# Valdok I - Proposed New Residential Construction Project (DPD #3018670)

## Presentation Package

### SEATTLE DESIGN REVIEW

12.22.2014 | Early Design Guidance Meeting 1  
06.15.2015 | Design Review Recommendation Meeting 1

AERIAL FROM EDG MEETING #1

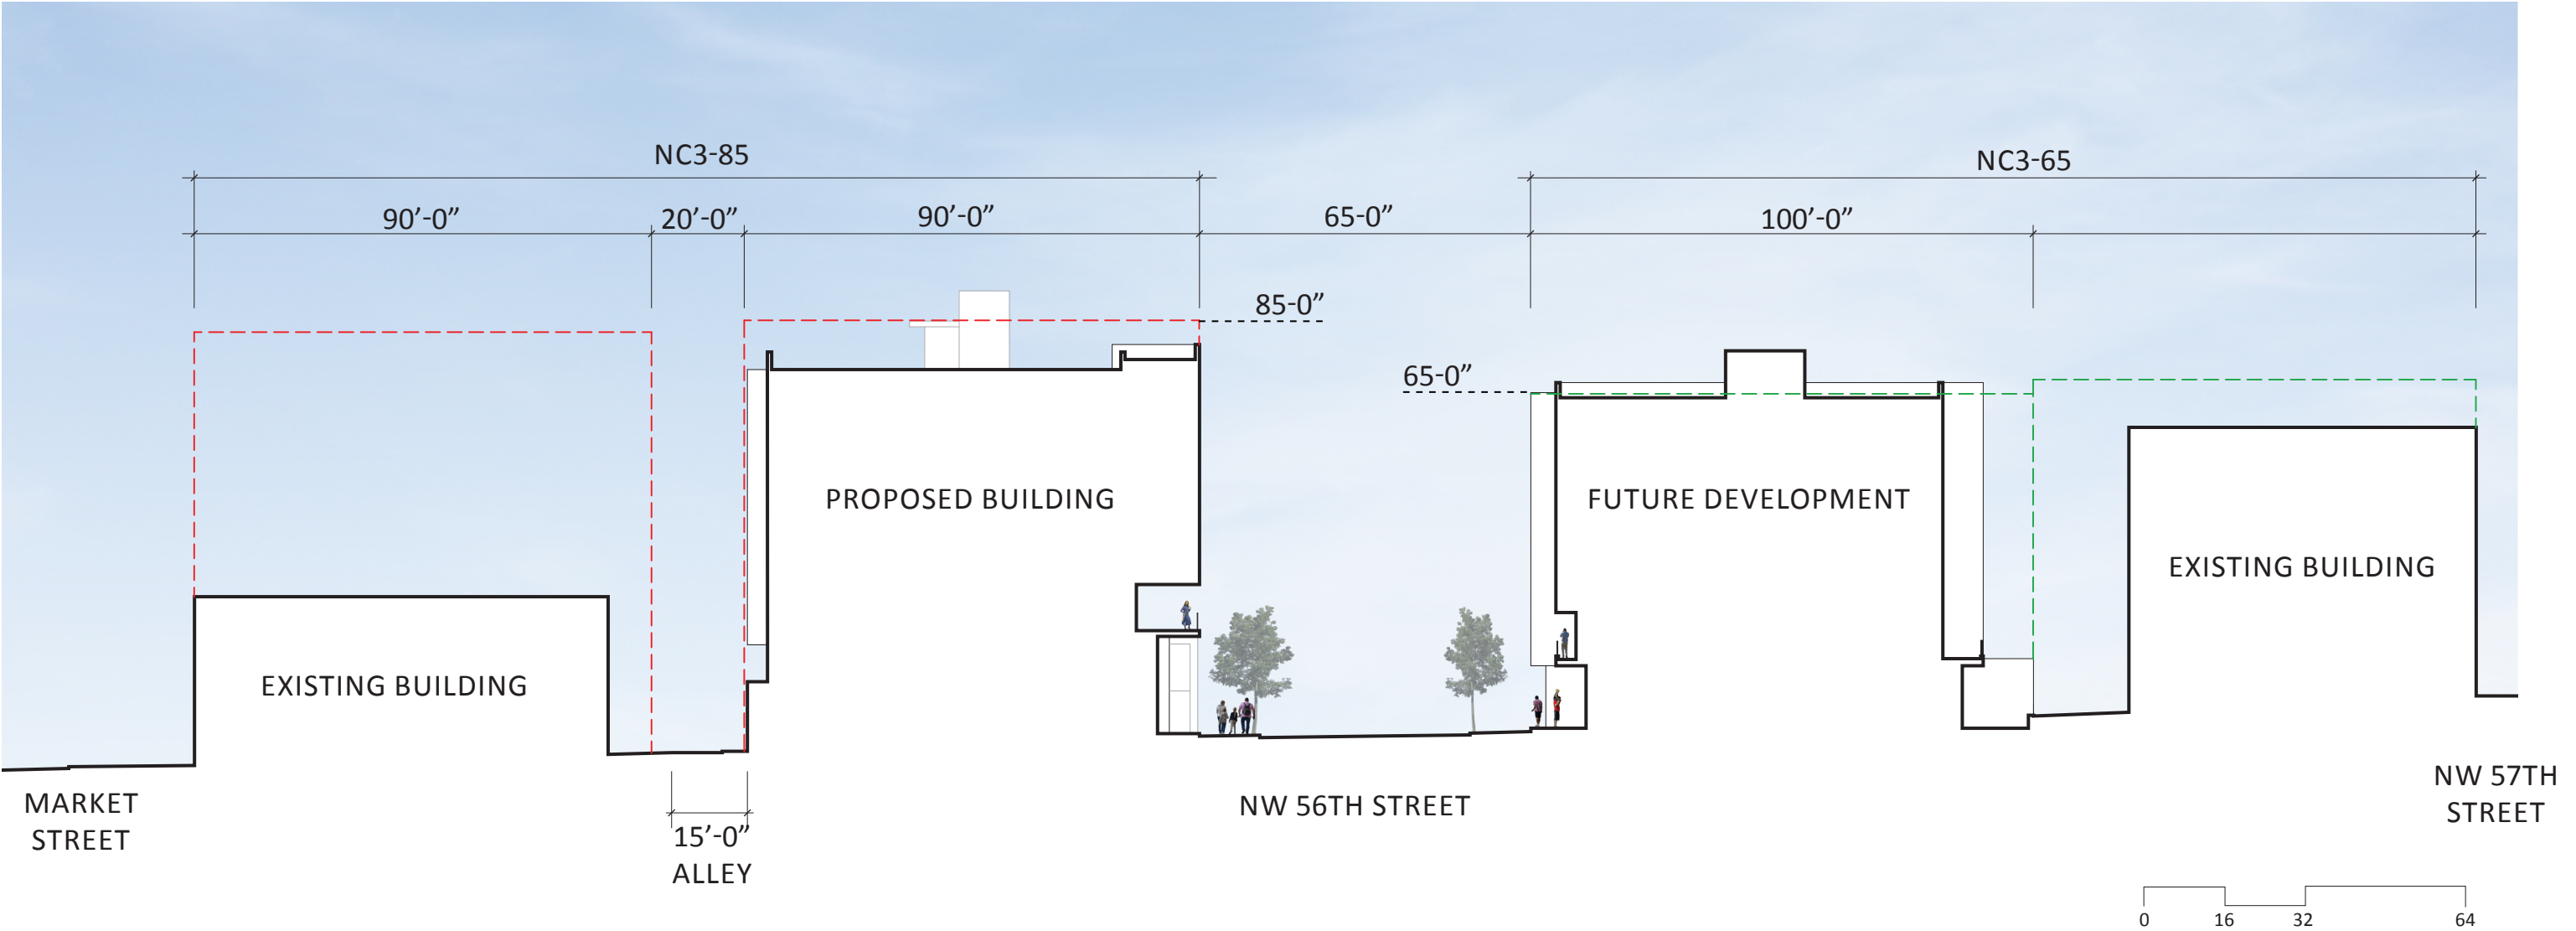
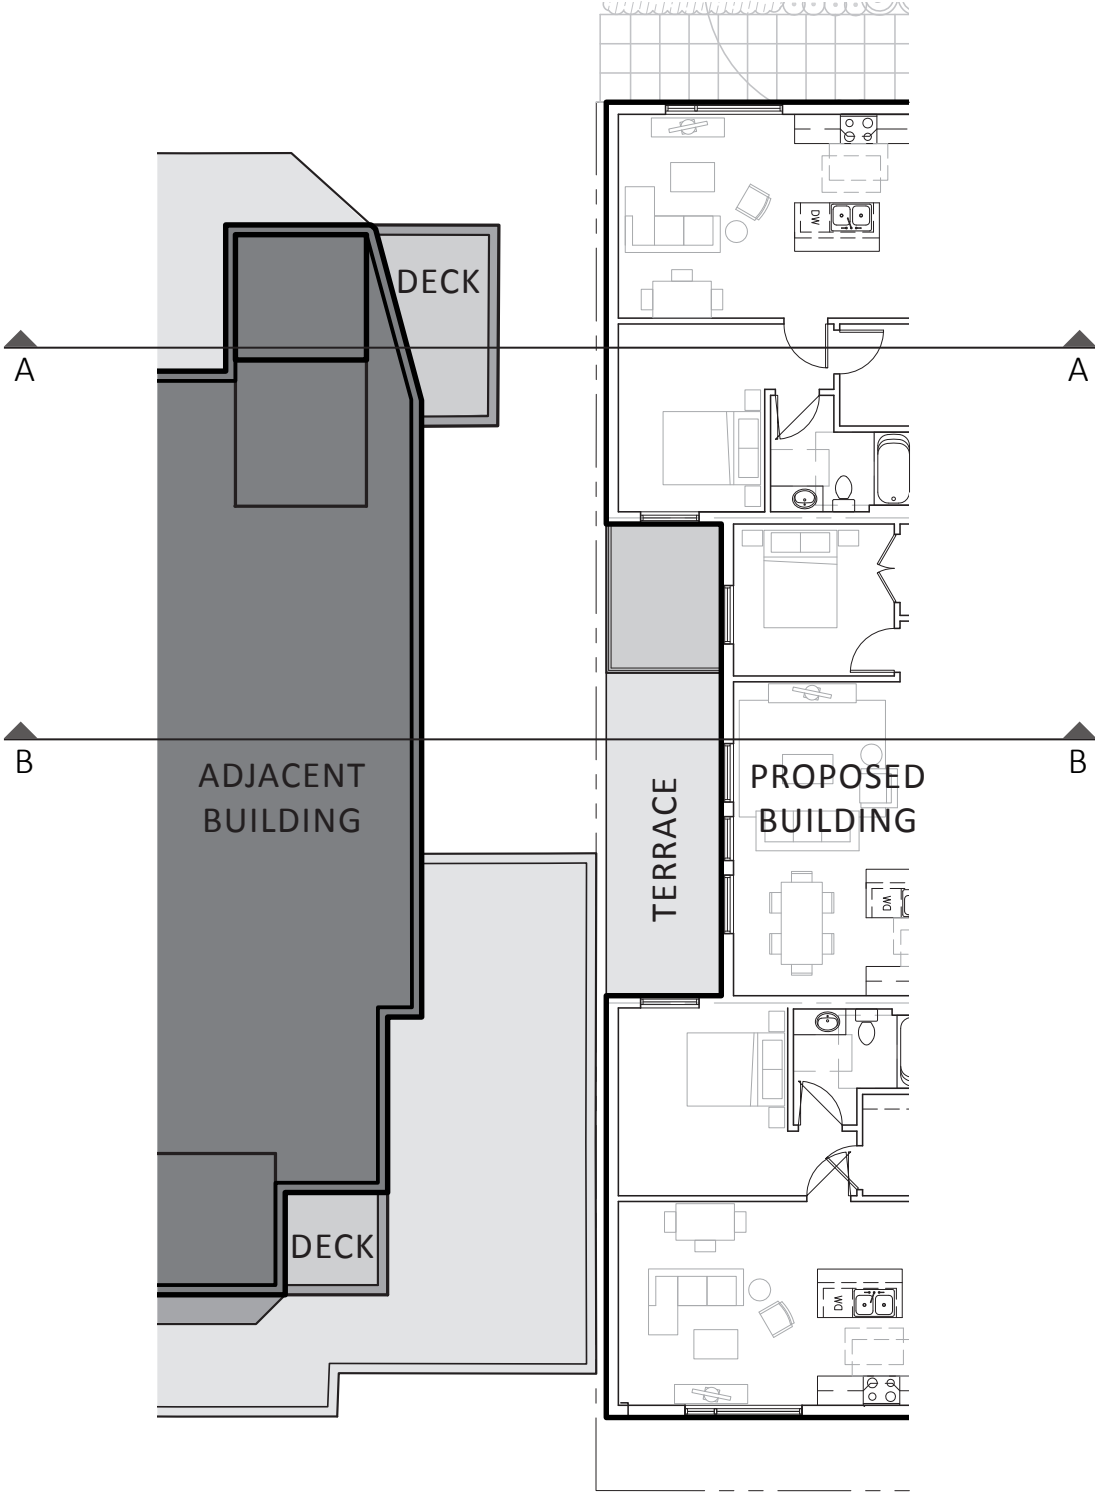
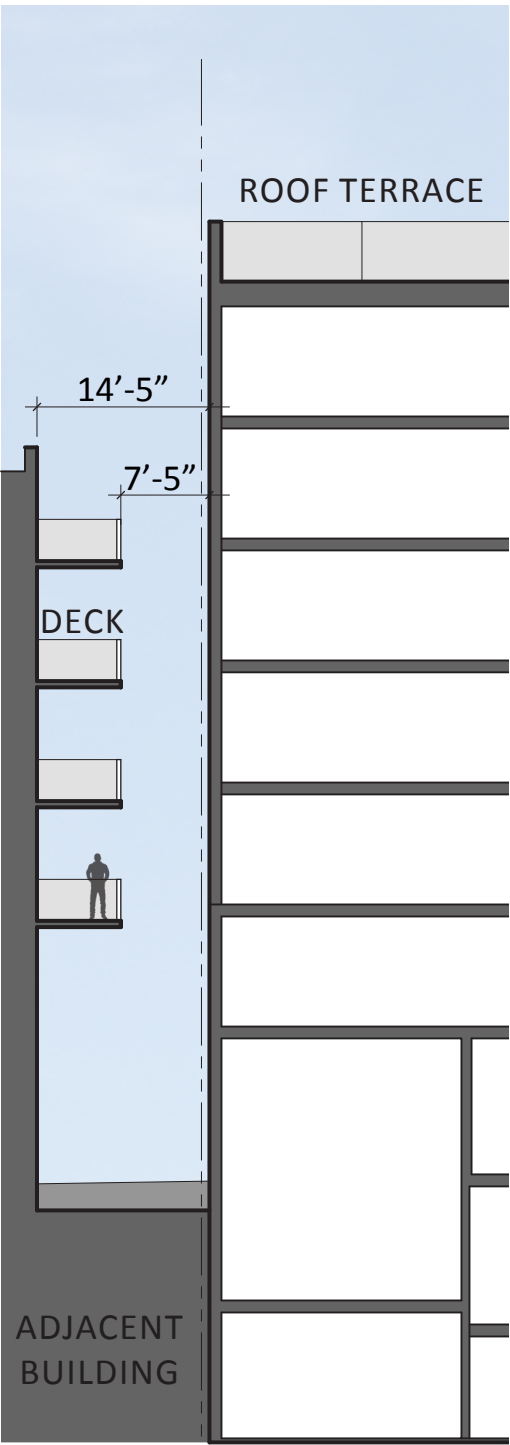
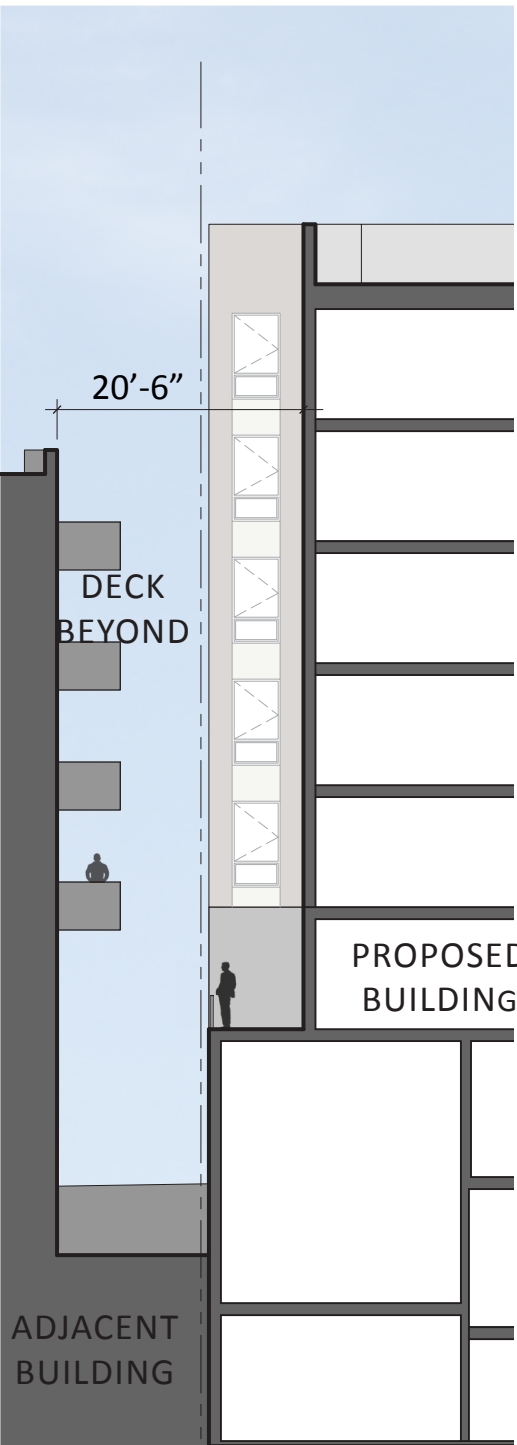
*“The proposed north-facing facades did not clearly address the zone change at NW 56th Street and the smaller residential structures currently across the street.”*

*“The Board asked the design team to consider the impact on existing smaller structures, in particular the smaller structure to the west of the development site. This consideration would examine blank walls, window adjacencies, the effectiveness of voluntary setbacks, etc.”*

**CS2-D-1 EXISTING DEVELOPMENT AND ZONING:**  
*Review the height, bulk, and scale of neighboring buildings as well as the scale of development anticipated by zoning for the area to determine an appropriate complement and/or transition.*

A - SECTION THRU PROPERTY LINE

B - SECTION THRU CENTER @ SETBACK

## DC2-A-2. REDUCING PERCEIVED MASS:

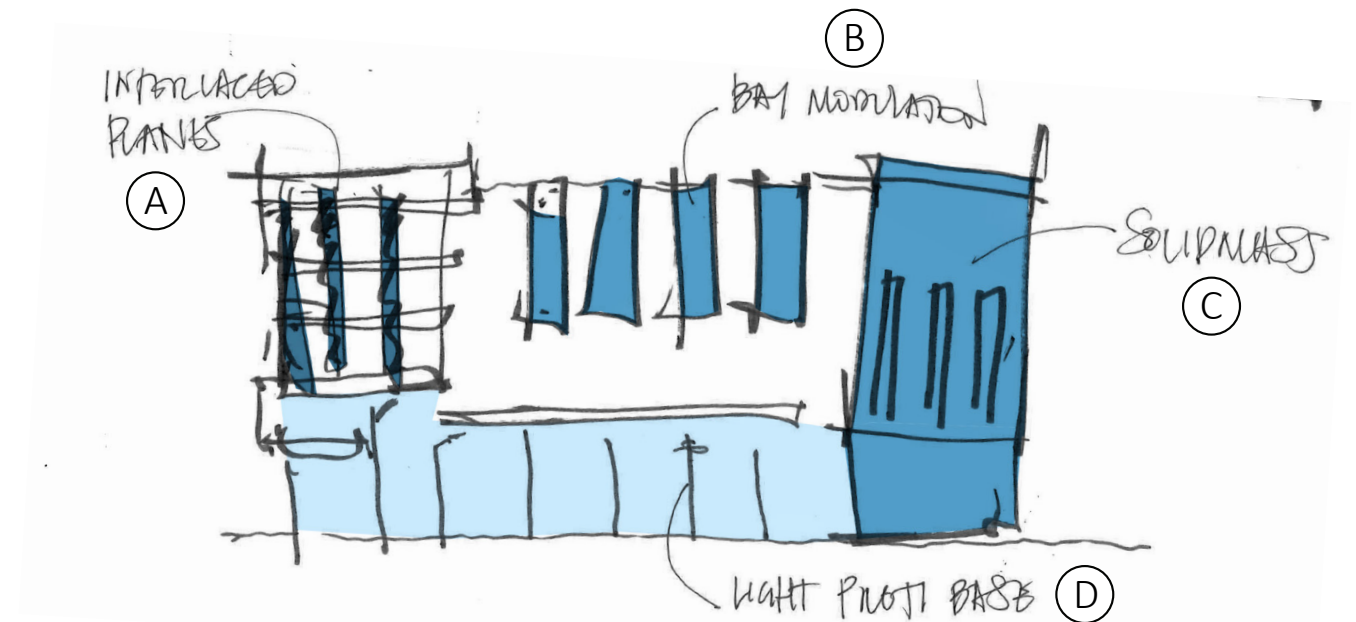
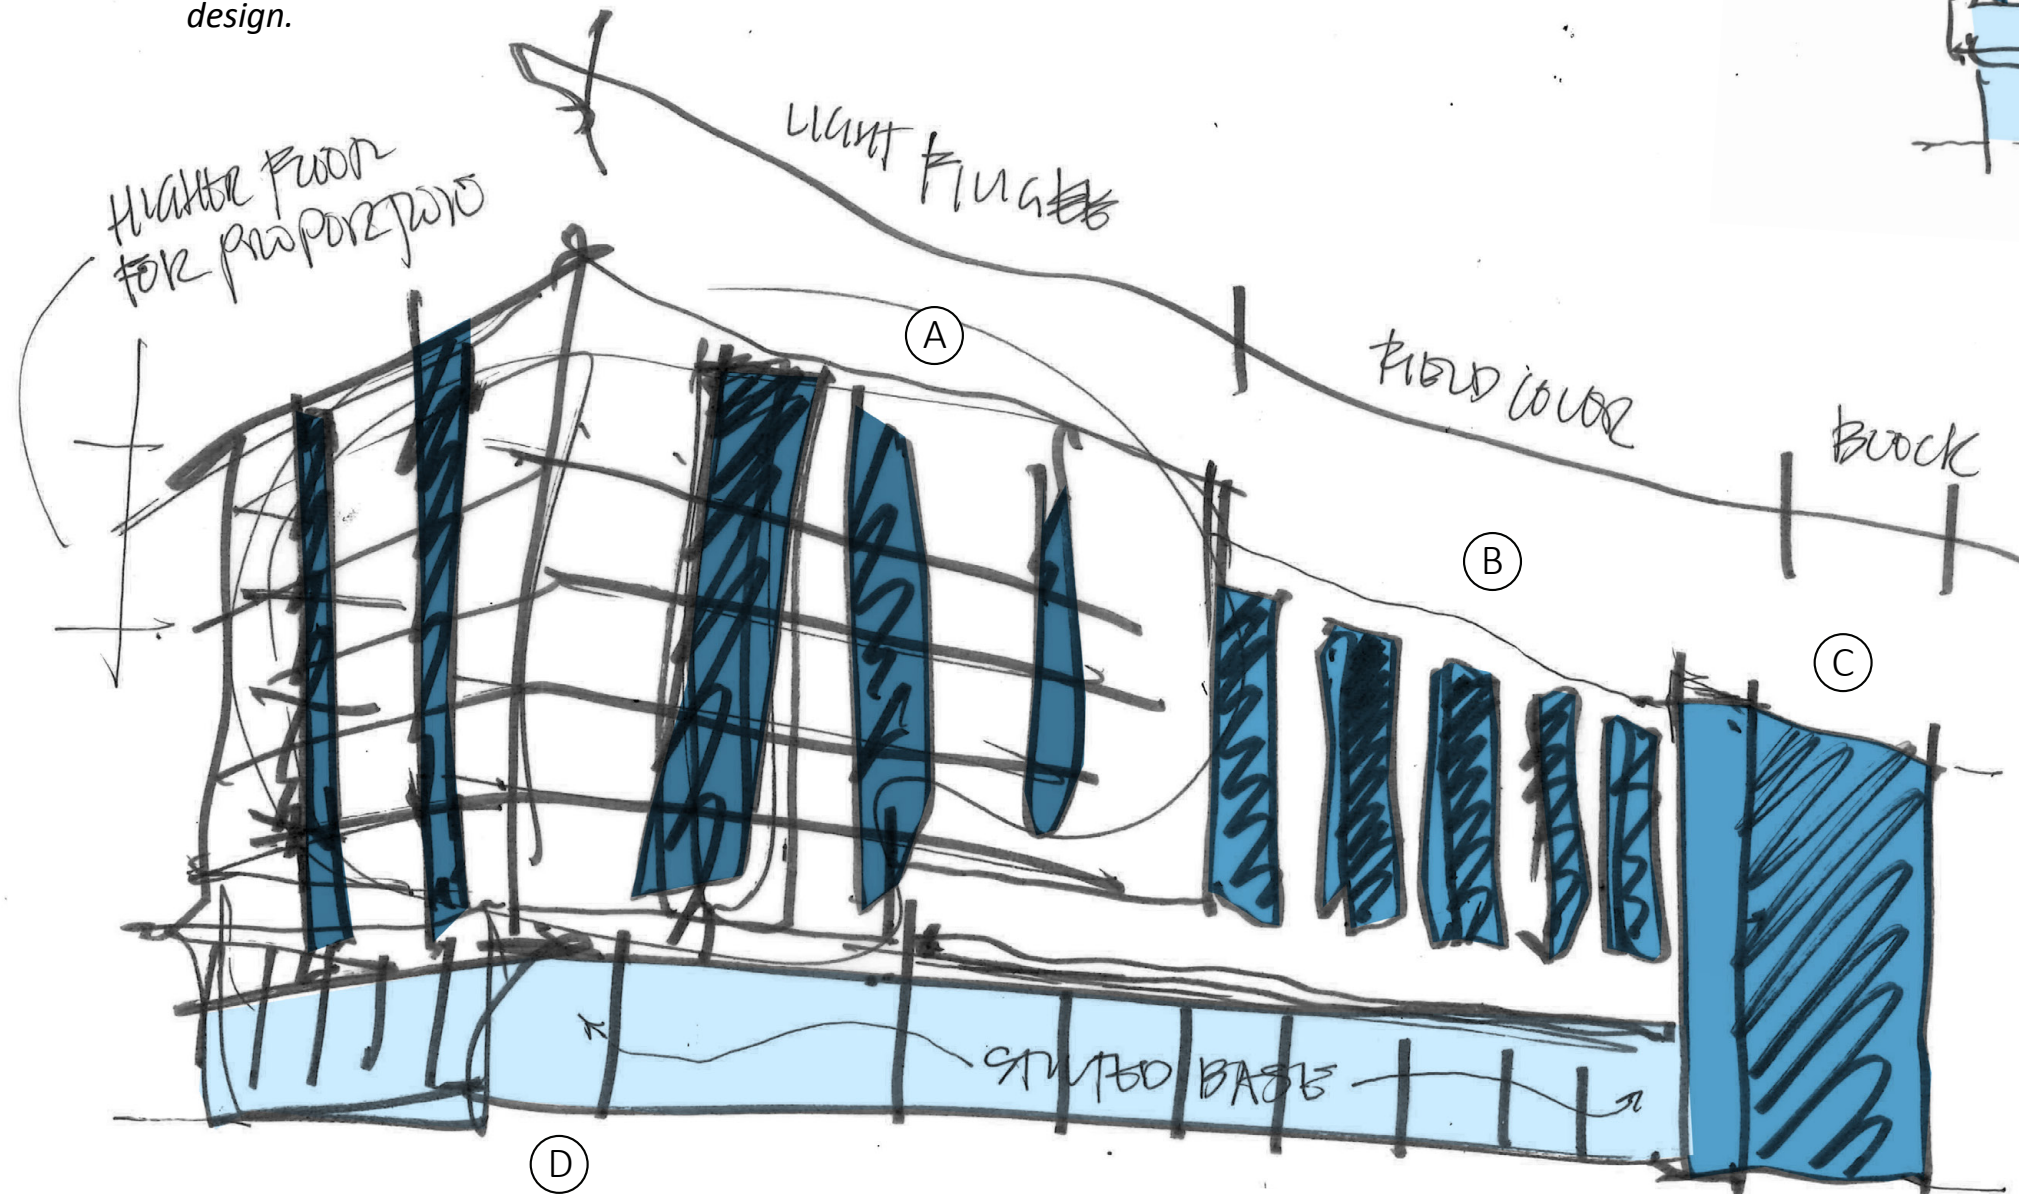
*“It was noted that this was a big (long at 300 feet) ) building that needed to be broken up along a finer scale. Although the preferred option divided the massing along NW 56th Street into three parts, the Board noted that there was no compelling reason for the symmetry of the north façade of the structure—the book ends or towers need not be equal in breadth and bulk; the west end, for example might better transition to the building to its side by losing some height. The Board requested further exploration of the massing that would diminish the perception of height, bulk and scale.”*

In an effort to break down the scale, the design team divided the massing into 4 main parts.

- (A) Overlapping vertical and horizontal banding, creating a light "filigree" at the prominent east corner.
- (B) Mass held back from street and punctuated with slender bays at the middle of the block.
- (C) Solid block that anchors the building to the west.
- (D) Undulating, glassy, "stilted base" at the pedestrian friendly ground floor.

The distribution of space and differentiation in massing of the upper floors is intended to break up and add interest and scale to what could otherwise be an very long and monotonous façade. The light semitransparent base helps to thread the neighborhoods existing commercial and pedestrian friendly fabric through our site.

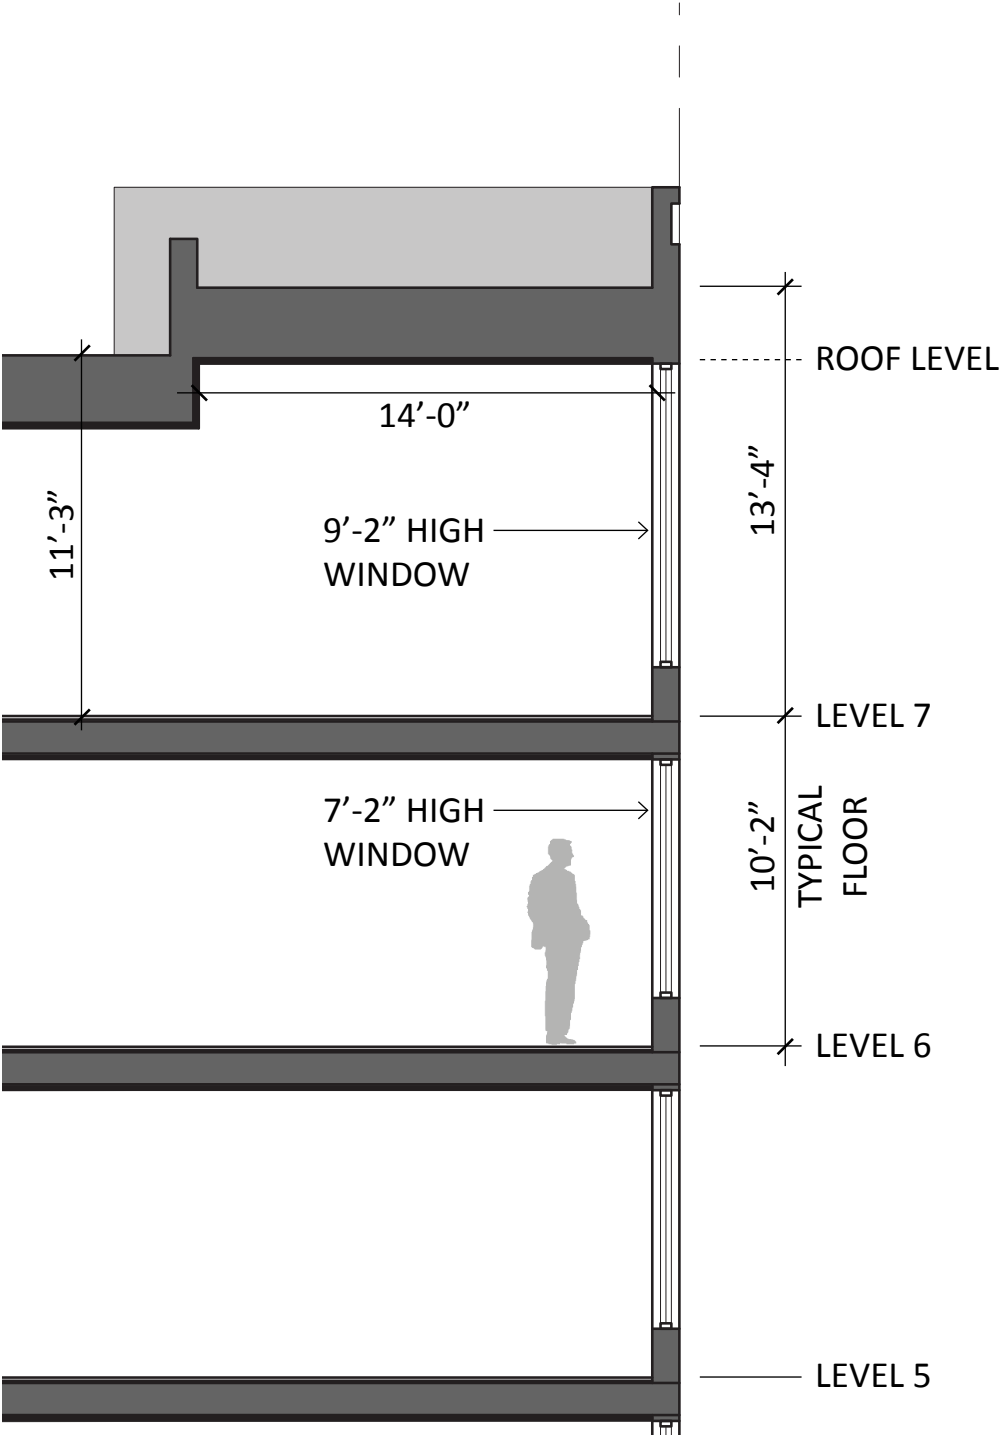
*“Think glass for overhead weather protection to allow ample lighting for safety, vitality of plantings, etc.”*

*“The entries should be clearly readable and the primary residential entry should receive treatment as ‘primary.’”*

*“It was not clear how the live/work spaces were intended to work and function as live/work spaces: would they provide a porous edge, with transparency, along the sidewalk? How could they effectively engage the sidewalk and enhance the pedestrian experience on NW 56th Street while still maintaining an element of privacy?.”*

*“For the landscaping, play with an integrated water element tying the building and ground plane together.”*
